UNITED STATES PATENT AND TRADEMARK OFFICE

APPLICATION NO.	FILING DATE	FIRST NAMED INVENTOR	ATTORNEY DOCKET NO.	CONFIRMATION NO.
10/779,942	02/17/2004	Michal Aaron Hastings	FUELP0242US	9368
7590 08/19/2004			EXAMINER	
Renner, Otto, Boisselle & Sklar 19th Floor 1621 Euclid Ave. Cleveland, OH 44115			TRIEU, THAI BA	
			ART UNIT	PAPER NUMBER
			3748

Office Action Summary

DETAILED ACTION

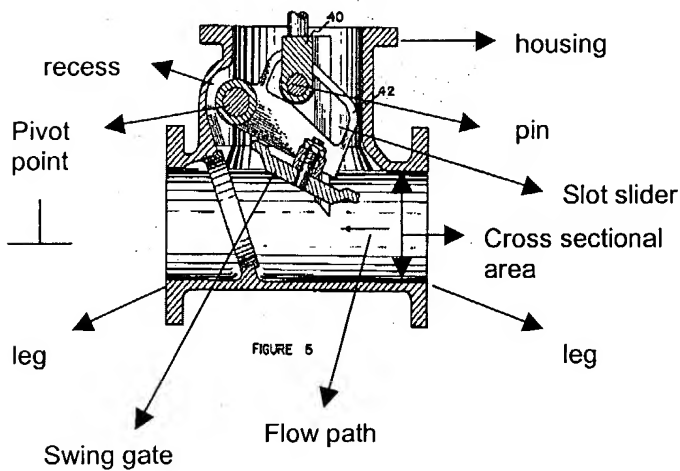
Claims 1-7, 9, 12, 14 are rejected under 35 U.S.C. 102(b) as being anticipated by Hay (Patent Number 3,334,858).

Regarding claims 1-7 and 9, Hay discloses a remote wastegate for a turbocharged internal combustion engine system, comprising:

a housing (Not numbered, see attached Figure 5) having a passage defining a path for the flow of exhaust gases

a swing gate pivotally mounted in the passage for movement between a closed position that blocks the flow of exhaust gases through the passage and an open position that allows the flow of exhaust gases through the passage (See attached figure 5),

wherein the housing further includes a recess in the passage into which the swing gate is at least partially received in the open position to allow an unrestricted flow of exhaust gases through the passage (See attached Figure 5);

wherein when the swing gate is in the open position, a cross-sectional area of the flow path through the passage in the housing is substantially constant (See attached Figure 5);

wherein the control rod (19) is connected to the swing gate with a pin and slot slider arrangement (See attached Figure 5);

wherein the valve housing defines a ninety degree angle in the flow path (See attached Figure 5); and

wherein the swing gate has a pivot point that lies outside the flow path (See attached Figure 5).

a housing having a passage defining a path for the flow of exhaust gases from an inlet end of the passage to an outlet end of the passage (See attached Figure 5), and

a swing gate pivotally mounted in the passage for movement between a closed position that blocks the flow of exhaust gases through the passage and an open position that allows the flow of exhaust gases through the passage, wherein the housing has a ninety degree actuator parallel to one leg of the housing and the swing gate moves from a position blocking the flow through one leg to an open position removed from the blocking position to permit flow through the one leg (See attached Figure 5);

wherein the housing forms approximately a ninety-degree angle between two legs (See attached Figure 5).

Hay discloses the invention as recited above, and further discloses a recess in the passage receives at least a pad of the swing gate when the swing gate is in the fully open position (See attached Figure 5); however, Hay fails to disclose the swing gate including a sealing surface that mates with a seat that circumscribes the one leg when in the closed position.
